Response to Comments on  
EPA's Proposed Air Pollution Control Title V Permit to Operate  
No. V-IL-1716300103-2014-10 for

Veolia ES Technical Solutions, L.L.C.  
Sauget, Illinois

January 18, 2017

**Figure 1. Results of a comparison of mercury results reported by EPA Reference Method 30B and the Cooper Xact.**

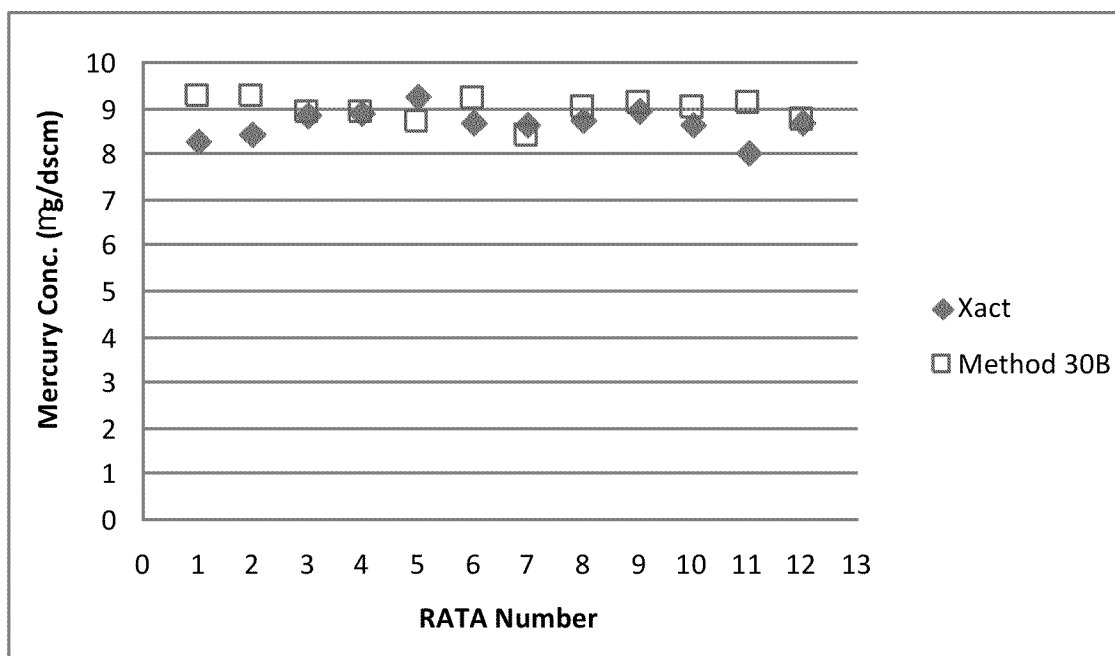
31. **Comment:** *The Xact multi-metals CEMS has never been tested or installed on incinerators such as those at Veolia.*

Figure 1, above, shows the results of a comparison of mercury results reported by EPA Reference Method 30B and the Xact.<sup>42</sup> These data were collected at a coal-fired utility boiler operating with dry controls at about 350 degrees Fahrenheit.<sup>43</sup> EPA believes that these results plus those in the appendix to the Lilly AMP clearly show that the Xact has demonstrated its ability to operate accurately and reliably for extended periods of time under a wide range of stack conditions, including those likely to be found in the Veolia stack. Also, the Xact multi-metals monitoring device successfully passed RATA testing on at least two Army hazardous waste facilities in Utah, thus demonstrating the accuracy of this unit for the conditions at a munitions incinerator.<sup>44</sup>
